Access Compliance Report

Public Rights-of-Way

(Curb Ramps)

Intersection ID: 51536	Main Street: GLENBURN_LN	Cross Street: LOCHY_LN	Location: NE
ADA ID: 3C3DFA4AD5BB	Ramp Type: BlendTrans1	Initial Pass/Fail: Fail	Overall Compliance: No
Severity Score: 10			
Codes/Mitigation Info/Possible Solution		Field Measurements/Component Compliance

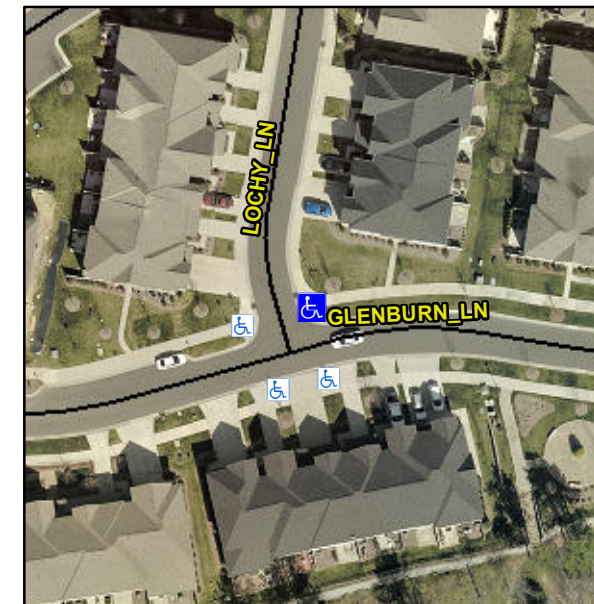
Not Found, R304.5.1, R304.5.3

Compliance	Description	Data	Compliance	Description	Data
N/A	Ramp Length (in)	82.0	Yes	BlendTrans Slope (%)	3.4
No	Ramp Width (in)	45.0	No	BlendTrans XSlope (%)	2.4
N/A	Flare Type LT	N/A	N/A	Flare Type RT	N/A
N/A	Flare Slope LT (%)	N/A	N/A	Flare Slope RT (%)	N/A
N/A	Flare Traversable LT?	N/A	N/A	Flare Traversable RT?	N/A
N/A	Landing Length (in)	N/A	N/A	DWS Provided?	N/A
N/A	Landing Width (in)	N/A	N/A	DWS Contrast?	N/A
N/A	Landing Slope (%)	N/A	N/A	DWS Length (in)	N/A
N/A	Landing X Slope (%)	N/A	N/A	DWS Full Width?	N/A
N/A	Landing Curb? (Y/N)	N/A	N/A	DWS Offset (in)	N/A
N/A	Shared Landing?	N/A			
N/A	Gutter Ponding?	N/A	N/A	Gutter Slope (%)	N/A
N/A	Gutter Lip Ht (in)	N/A	N/A	Gutter X Slope (%)	N/A
N/A	Painted X Walk1?	No	N/A	Painted X Walk2?	No
	X Walk 1 Direction	To W		X Walk 2 Direction	To S
	X Walk 1 Width (in)	N/A		X Walk 2 Width (in)	N/A
	X Walk 1 Slope (%)	1.4		X Walk 2 Slope (%)	2.7
	X Walk 1 X Slope (%)	4.4		X Walk 2 X Slope (%)	0.1

N/A	Ramp inside XWalk1?	N/A	N/A	Ramp inside XWalk2?	N/A
	Road Slope (%)	3.3		Clear Space?	N/A
	Road X Slope (%)	3.1	N/A	Clear Space to XWalk (in)	N/A
N/A	Any Obstructions?	N/A	N/A	Storm Grate/Utility Hazard?	N/A
	Obstruction Type			Storm Grate/Utility Type	
		N/A			N/A
			Yes	Surface Condition? (G/P)	Good
			No	Curb Slope (%)	7.9

Remove & Replace Curb Ramp With Two New Directional Ramps or Equivalent.
